ADDENDUM NO. 2 TO PROJECT NO. M2975

**CONSTRUCTION WORK
REPAIR FAILING PARAPET AND MASONRY
WENDE CORRECTIONAL FACILITY
3040 WENDE ROAD
ALDEN, NY**

November 2, 2011

DRAWING NUMBER:
A202
SHEET 5 OF 14

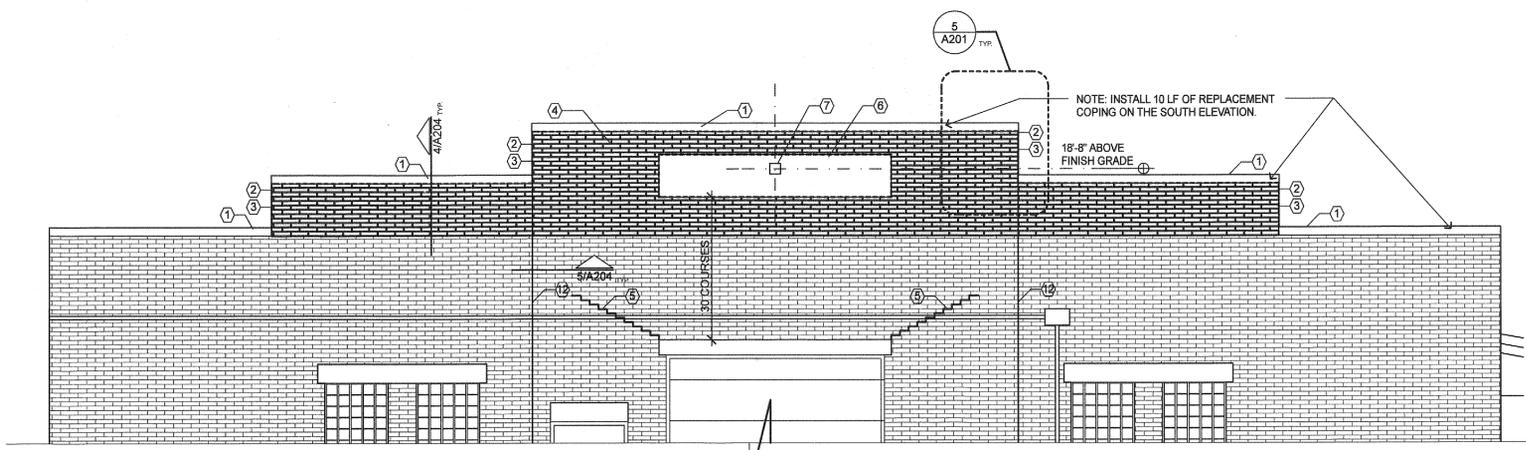
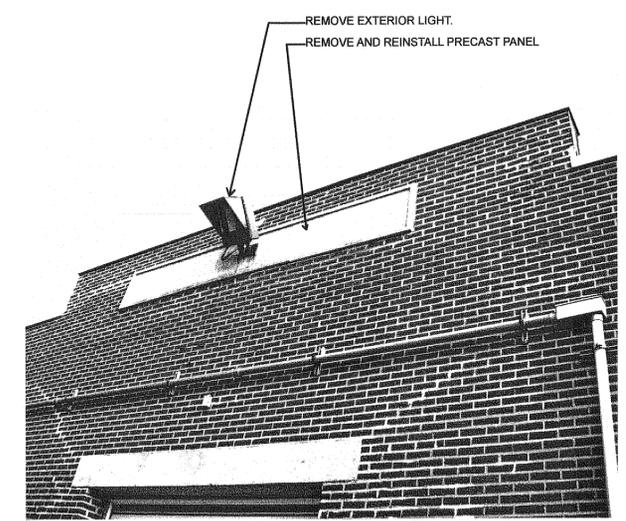
2. Revised Drawing
 - a. Drawing No. A-202, dated 10/14/11 noted “Addendum Drawing” accompanies this Addendum and supersedes the drawing bound in the Project Manual.
 - b. Drawing No. HMA-201 dated 11//02/11 noted “Addendum Drawing” accompanies this Addendum and supersedes both drawings HMA-201 and HMA-202 bound in the Project Manual.
3. Drawing Nos. A201, A203, A204, A205, A206, A207, and A208
 - a. DEMOLITION KEY NOTES, Change Note 3 to Read:
 - “3. Existing EPDM termination bars to be removed and disposed of as Asbestos Containing Material.”
 - b. KEYNOTES, Change Note 3 to Read:
 - “3. Provide new EPDM termination bars.”
